ST. TAMMANY PARISH

Addendum No.: 1

Bid#: 26-16-2

Project Name: Rosedown Way Drainage – Phase 2

PROJECT NO. 11813
SHEET NO. 5

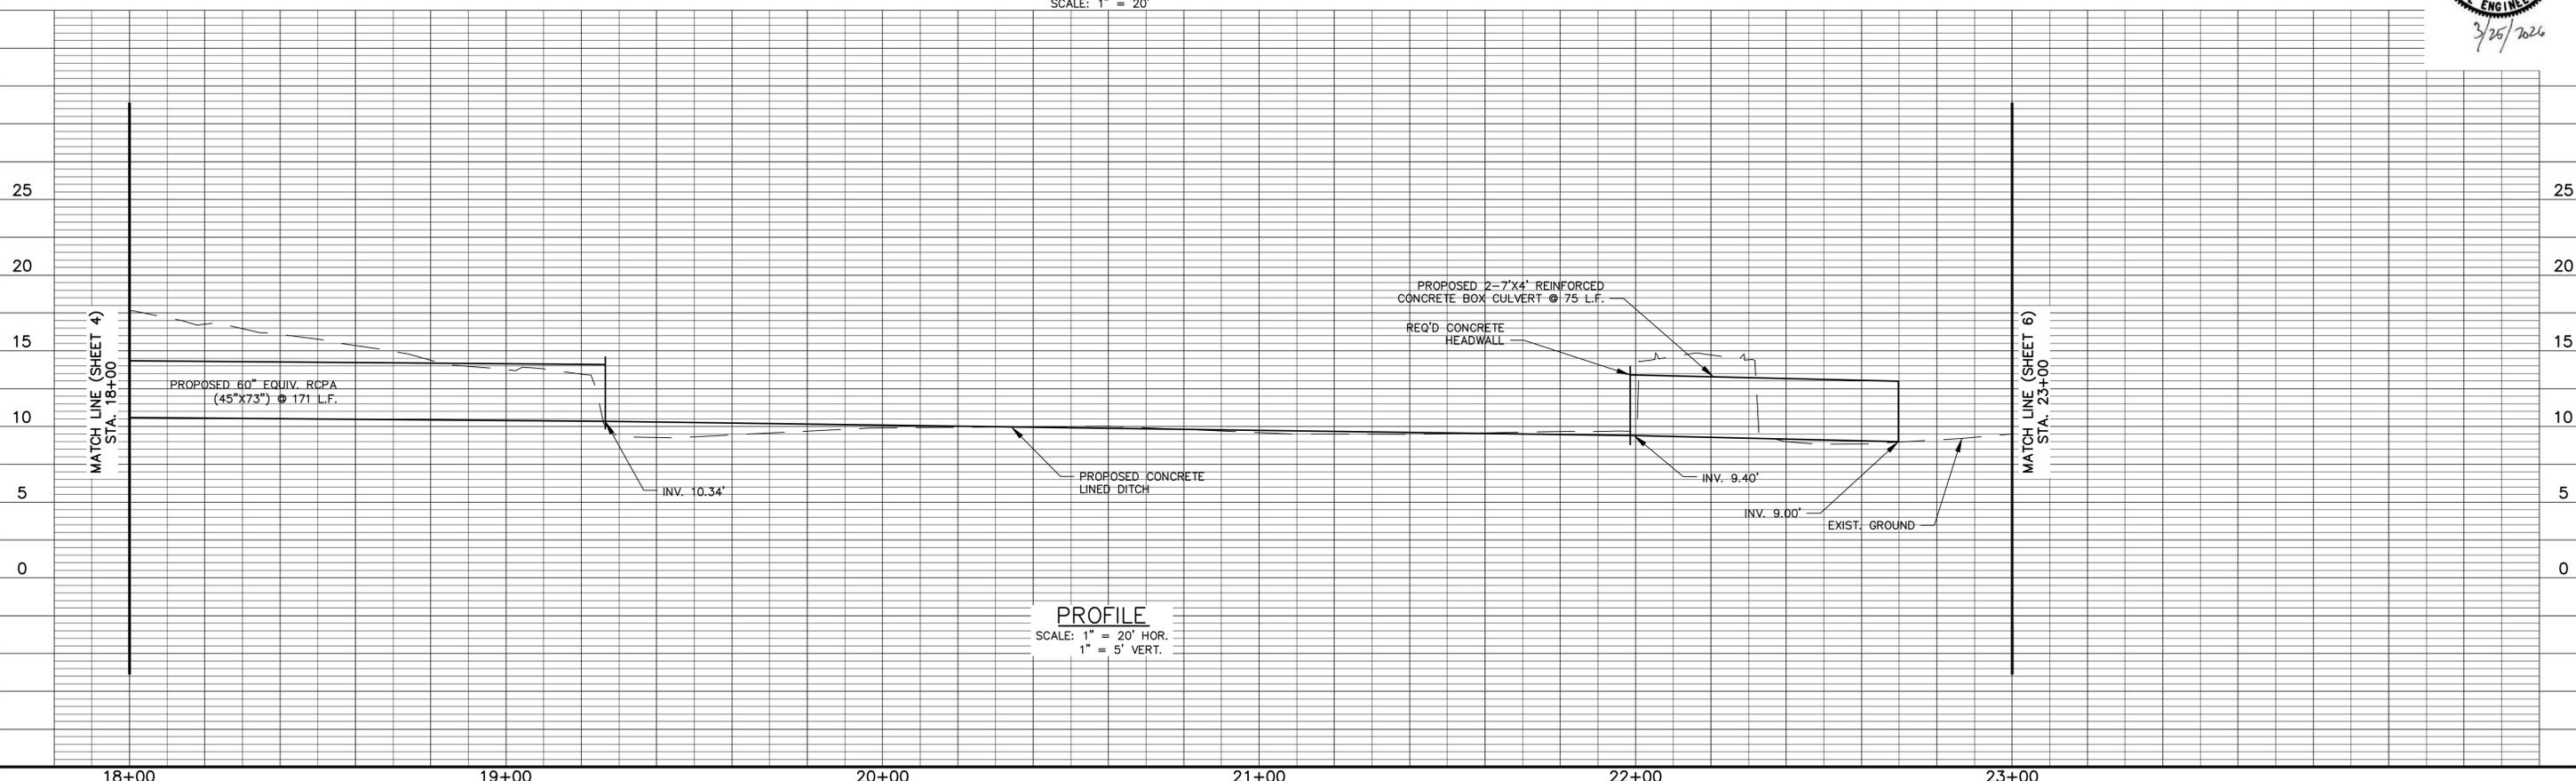
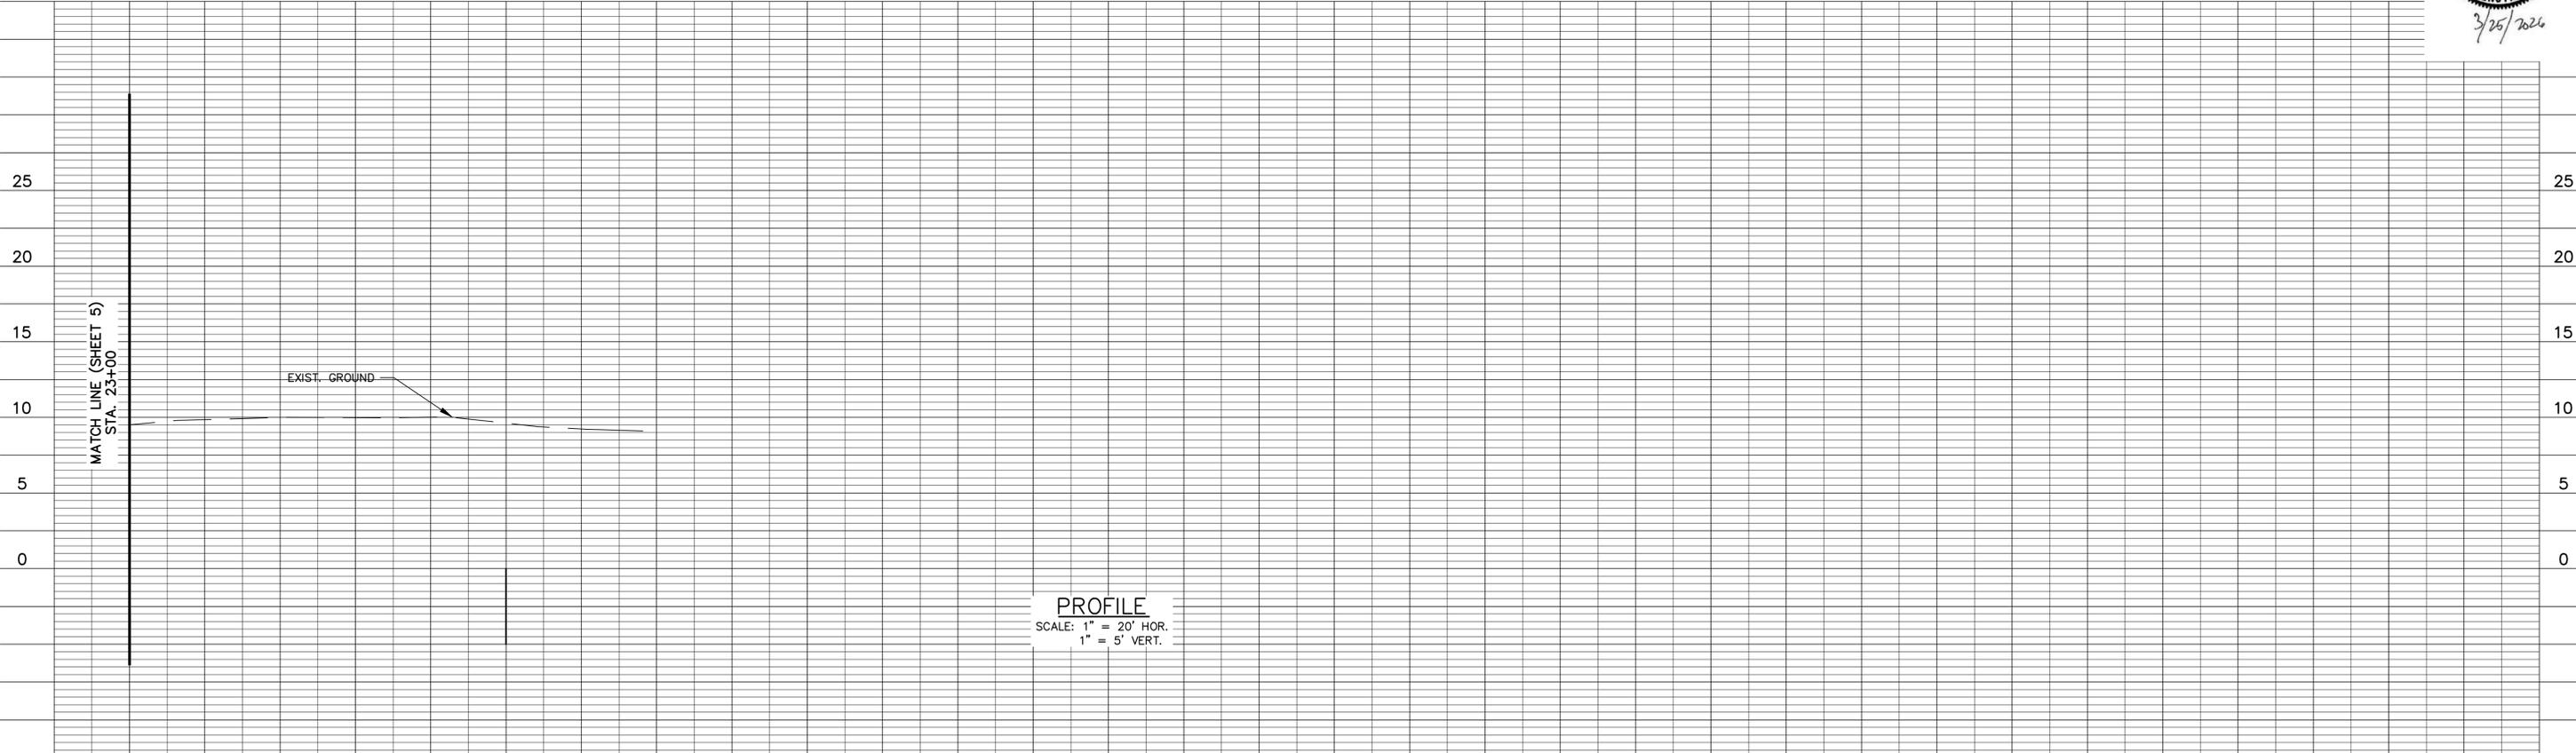
Question 7. For removal of structures, it is difficult to know what exactly will need to be removed. Can you make that clearer for contractors? For instance, on page 5 will all the items highlighted need to be removed (headwall, all concrete, piping, drop inlet, etc?)

Answer 7. Yes, please refer to the referenced plans in this addendum.
